**GENOA CHARTER TOWNSHIP
PLANNING COMMISSION
PUBLIC HEARING
AUGUST 9, 2021
6:30 P.M.
AGENDA**

Attention:	Kelly Van Marter, AICP Planning Director and Assistant Township Manager
Subject:	Highland Engineering – Sketch Plan Review #1
Location:	1125 and 1153 Grand Oaks Drive – east side of Grand Oaks, south of Grand River Avenue
Zoning:	IND Industrial District

Attention:	Kelly Van Marter, AICP Planning Director and Assistant Township Manager
Subject:	Tommy’s Express Car Wash – PUD Amendment and Site Plan Review #2
Location:	4591 E. Grand River Avenue – northeast corner of Grand River and Lawson Drive
Zoning:	NRPUD Non-Residential Planned Unit Development

**Re: Tommy's Express Carwash
Site Plan Review No. 2**

Project Manager:		BRUCE ZEINSTRAL, LLA	
Vertical Datum	NAVD 88	Horz. Datum	LOCAL
Drawn by: PETER BULTEN			
Checked by:	Survey	Date	
Civil			
Struc.			
L. A.			
HEI Project Number: 21-06-003			
Sheet Title: SITE LAYOUT PLAN			
Sheet No.: C-101

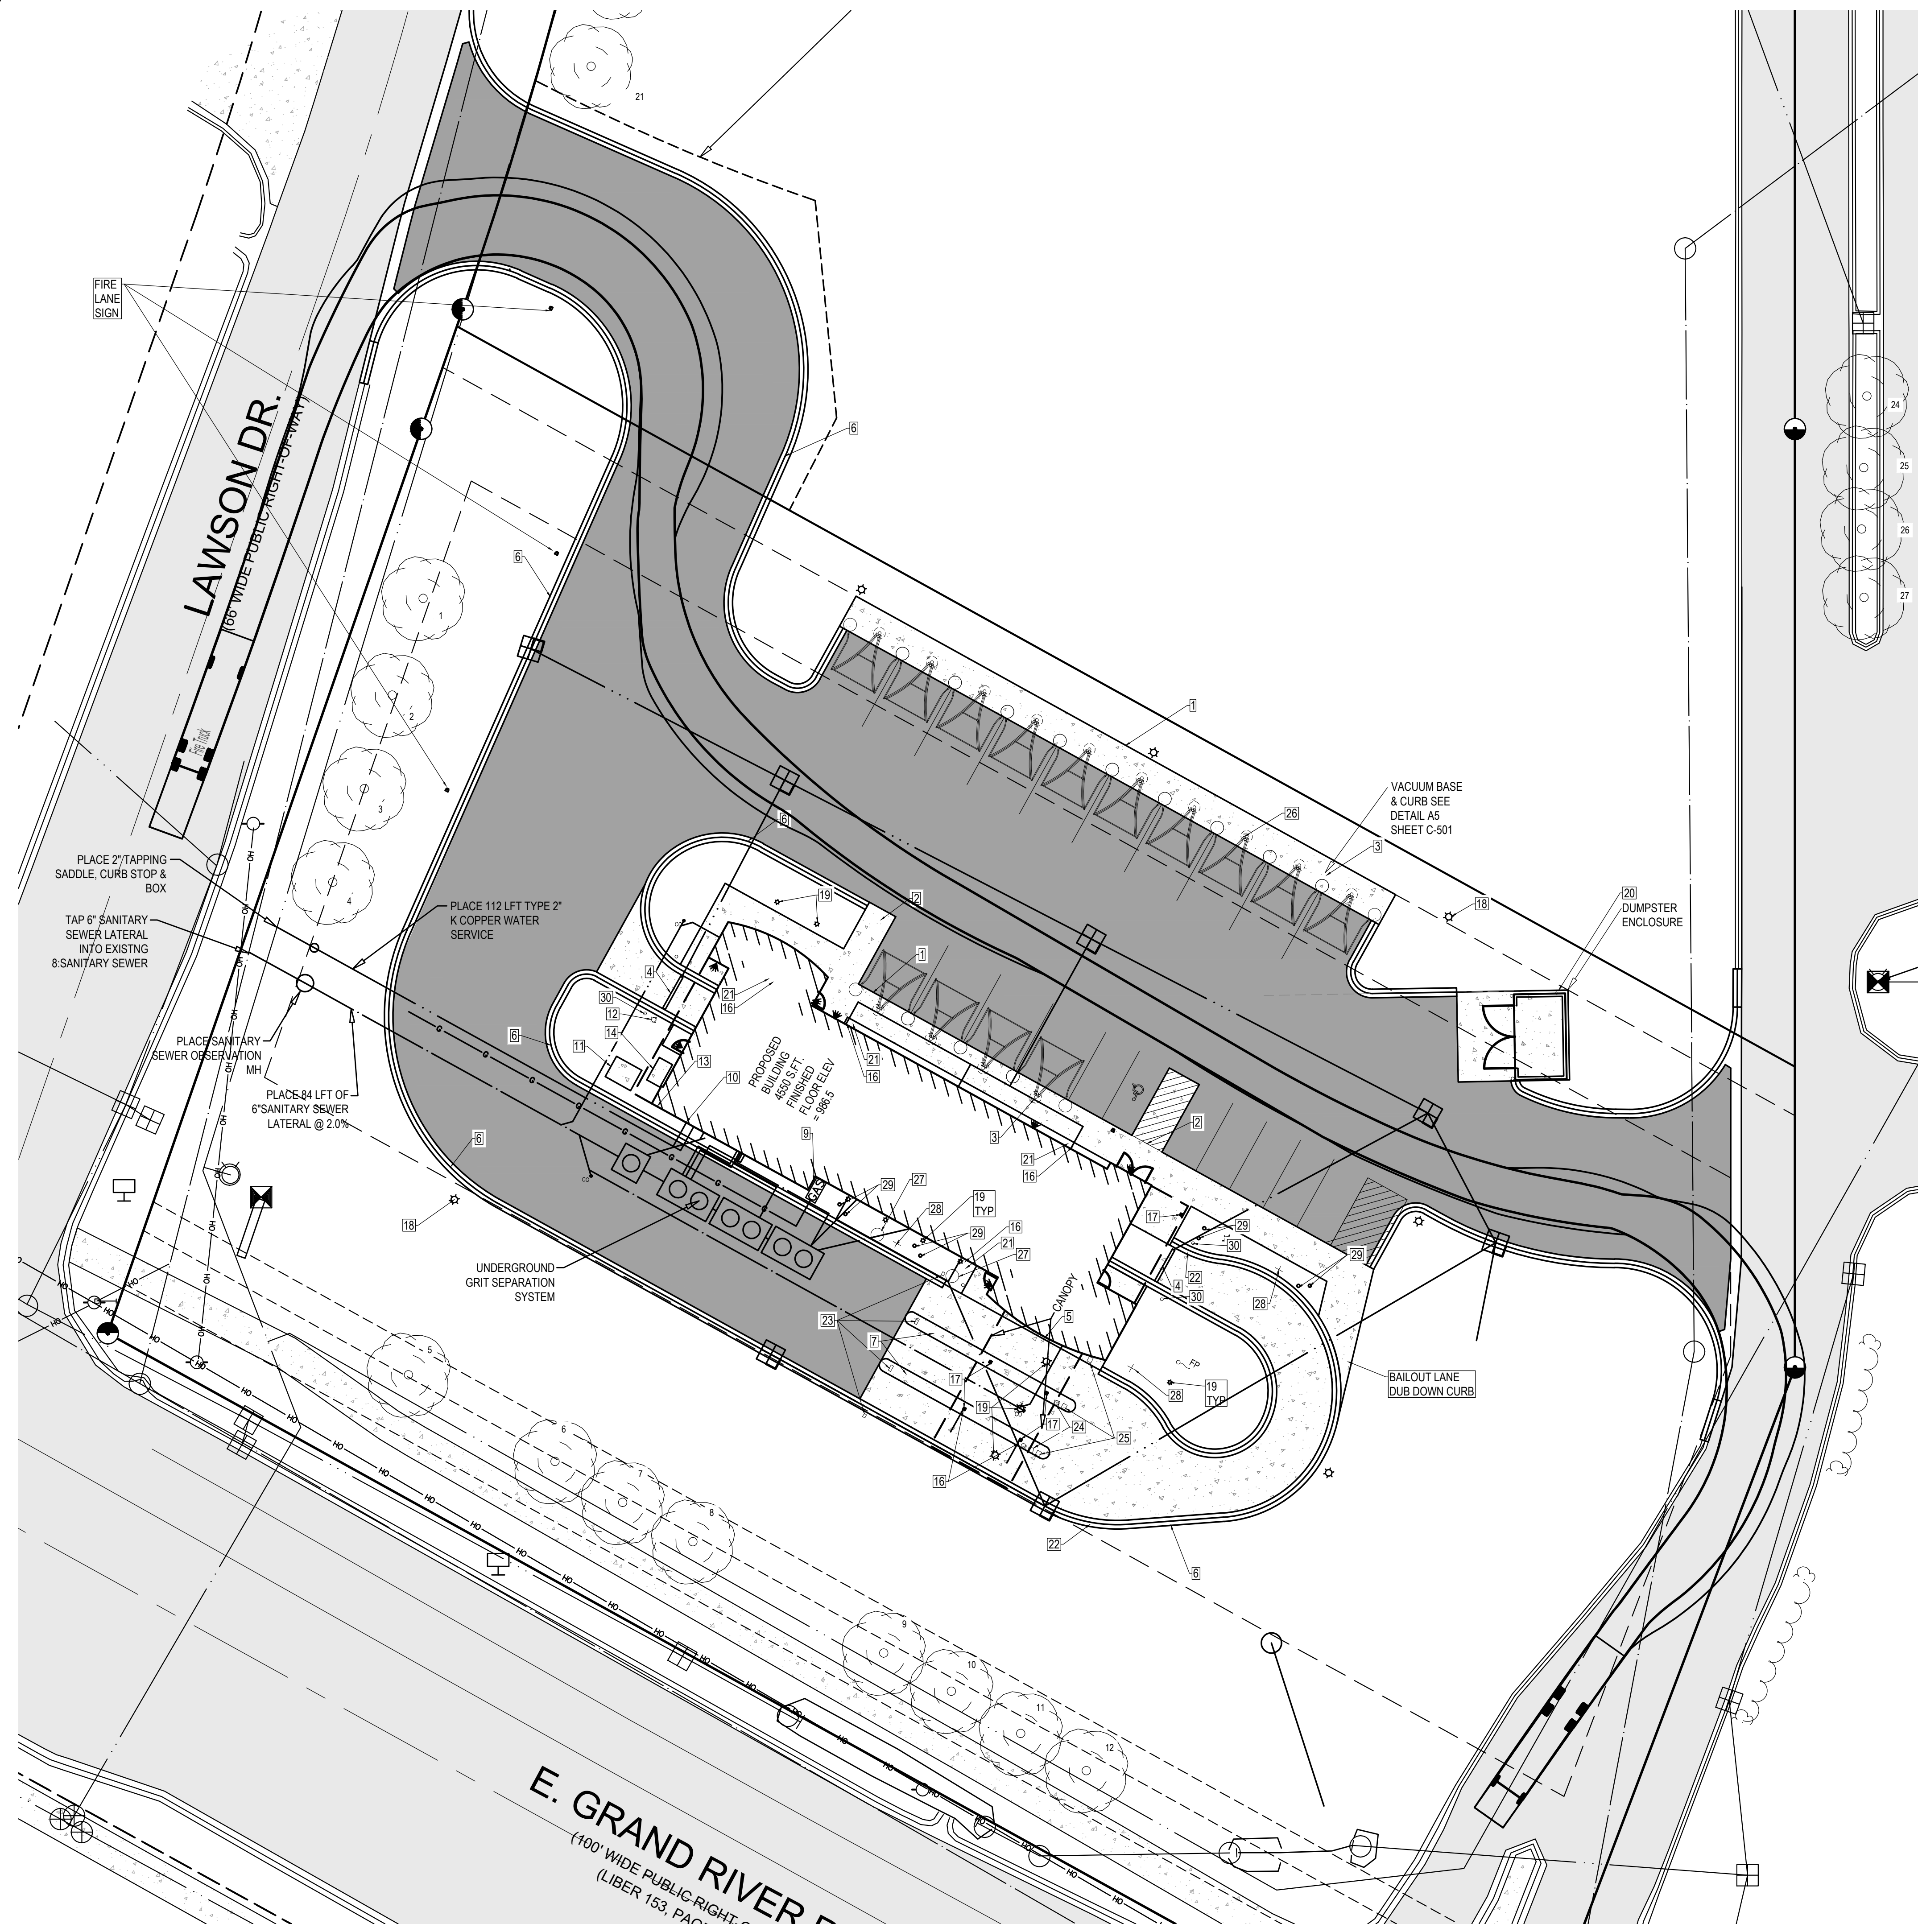
5. The location of a Knox Box shall be indicated on future submittals. The Knox box shall be located adjacent to the main entrance of the structure, in a location coordinated with the fire authority. **(Knox box is shown on Sheet C-101)**

C5 FIRE LANE SIGN

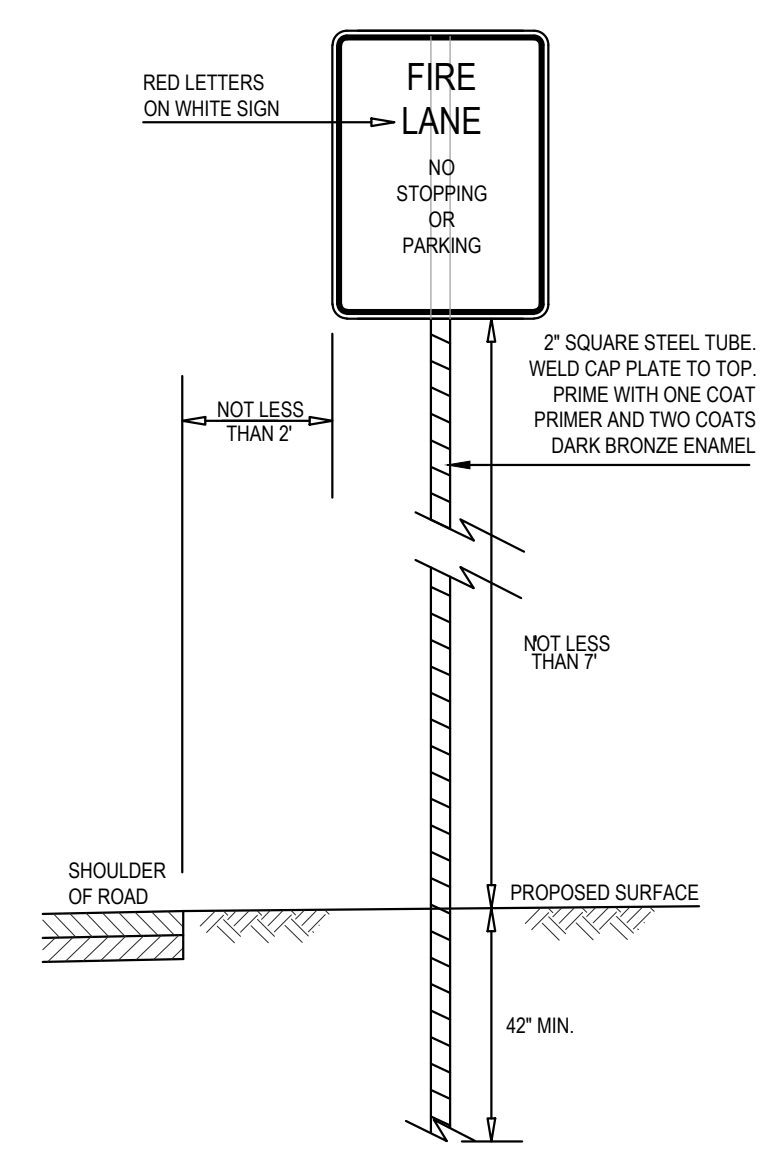
2. The entrance side of the access drives where parking is not provided shall be marked as a fire lane. Include the location of the proposed fire lane signage and a detail of the fire lane sign in the submittal. Access roads to the site shall be provided and maintained during construction. Access roads shall be constructed to be capable of supporting the imposed load of fire apparatus weighing at least 84,000 pounds. **(Fire lane signage has been provided as required. Drive will be engineered to provide capacity for emergency vehicles.)**
